1992 - 1993 Corvette: Service Bulletin: Cracks/Damage to Cowl Surface

Subject: CRACKS OR DAMAGE TO COWL SURFACE

Model and Year: 1992-93 CORVETTE WITH RPO LT1 ENGINES ONLY

Bulletin Number: 93-134-10

VIEW A

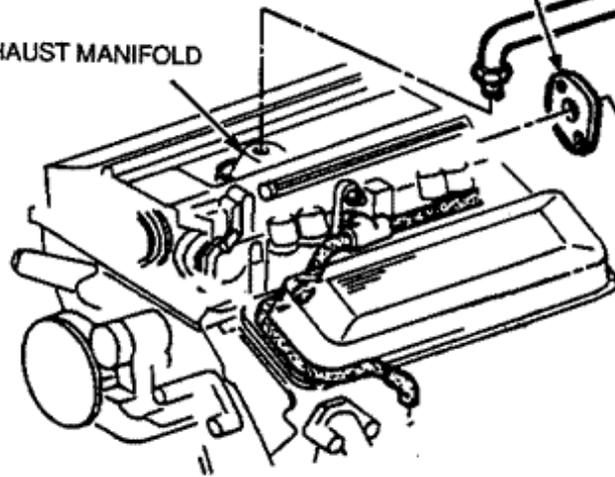
4. Remove right side A.I.R. pipe from engine (See View A);
 - a. Remove nut at exhaust manifold, use 22 mm "crow foot" wrench.
 - b. Loosen bolt on rear of head, using long 9/16" open end wrench.

- c. Remove bolts on rear of intake manifold, use 10 mm 1/4" drive socket and flex extension.
 - d. Remove hose and plastic clamp from check valve.
5. Clean damaged area (See View B) with a wax and grease remover and use V.O.C. approved materials where required.

VIEW C
(X SHOWS DAMAGE AREA)

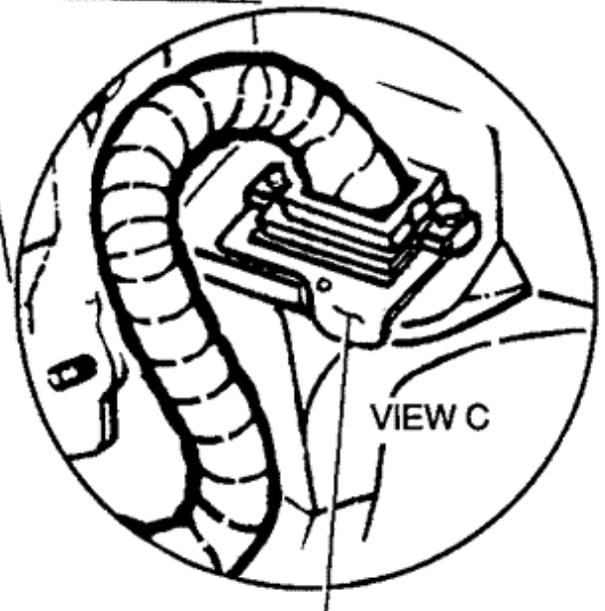
6. Apply enough seam sealing material to fill or cover the damaged area. Paddle material into place, if required.
7. Loosen the harness connector attaching bolts, position GM P/N 10231336 - Spacer, over the damaged area and under the attaching bolt heads and tighten the attaching bolts. The spacer has slots to aid in installation (See View C).

NEW PART IN POSITION
OVER DAMAGED AREA
